THE RESERVE AT CORRAL BLUFFS FILING NO. 3

A PORTION OF THE EAST HALF OF SECTION 31 AND WEST HALF OF SECTION 32
TOWNSHIP 13 SOUTH, RANGE 64 WEST OF THE 6TH P.M.
EL PASO COUNTY, COLORADO

REV. 8/25/20

FILE NO. SF-207

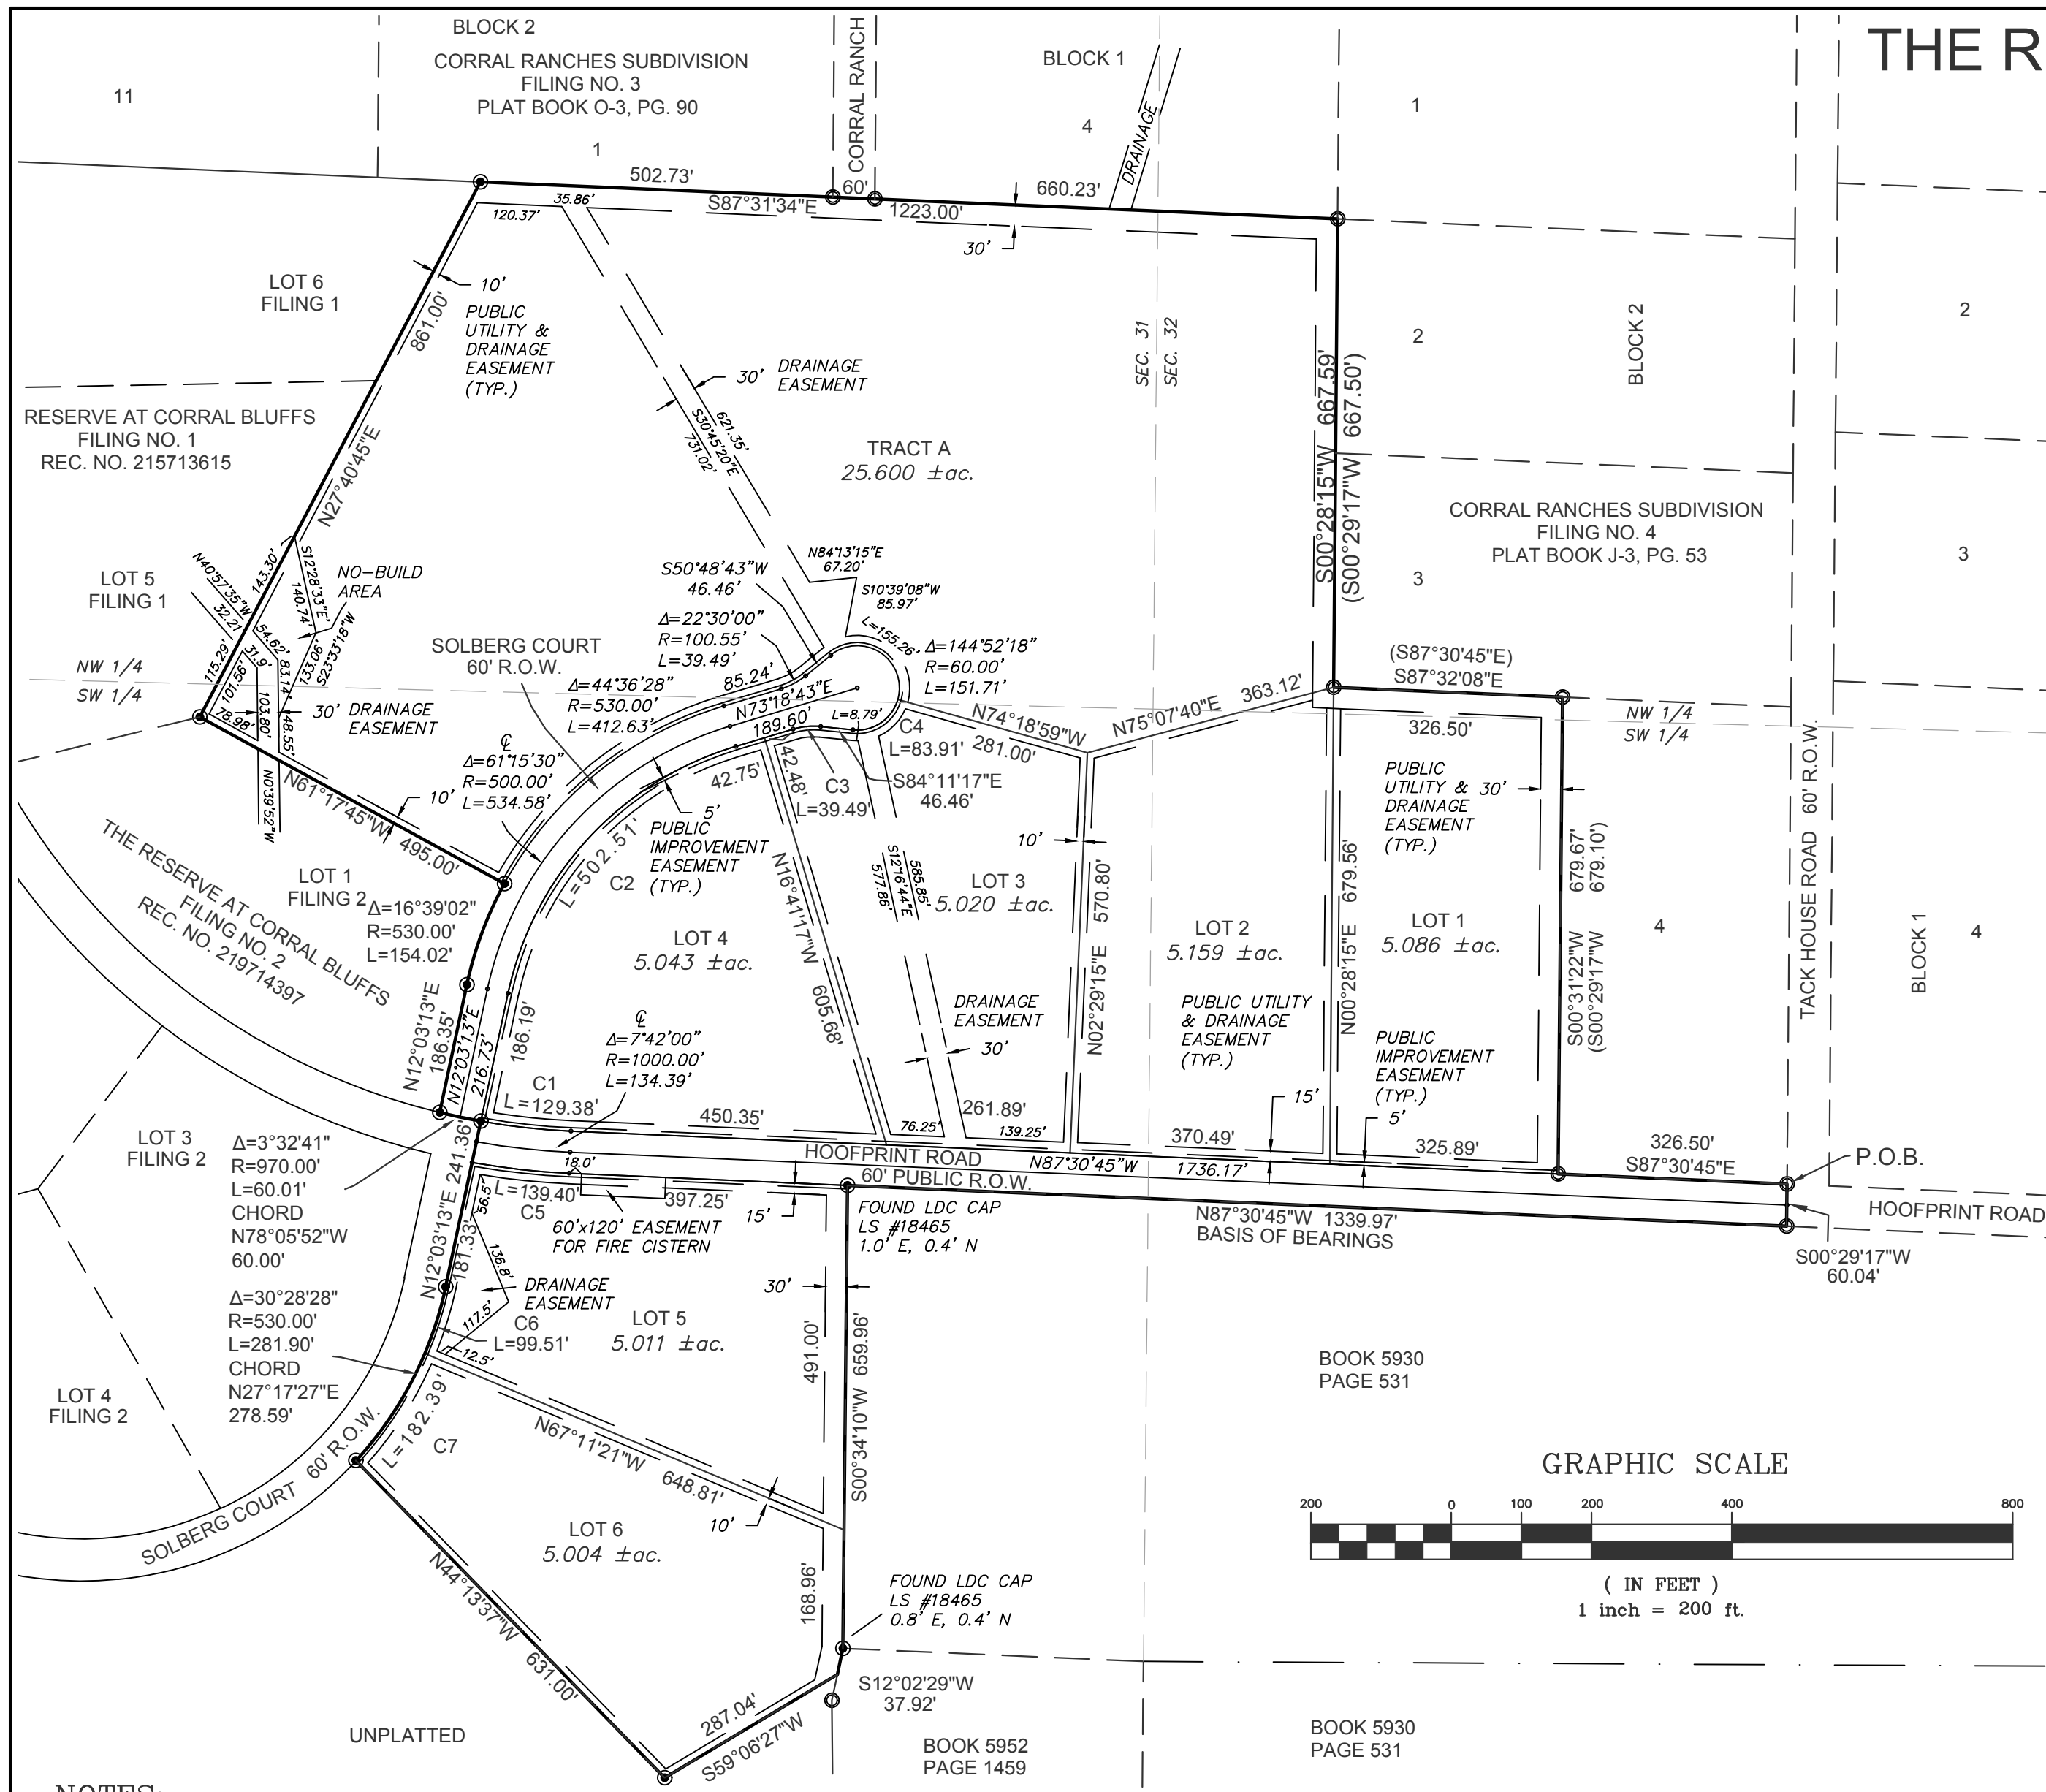
Add the following plat note:
Lot 5 of this property is subject to a Private Detention Basin/Stormwater Quality BMP Maintenance Agreement and Easement as recorded at Reception No. _____ of the records of El Paso County. The _____ HOA (or Owner or District) is responsible for maintenance of the subject drainage facilities.

Unresolved

Previous comment not addressed - verify information, soils and geology report indicate impacts to Lots 1, 2, 3, 4, 6, and tract A, and areas of ponding water should be no-build areas and should be depicted
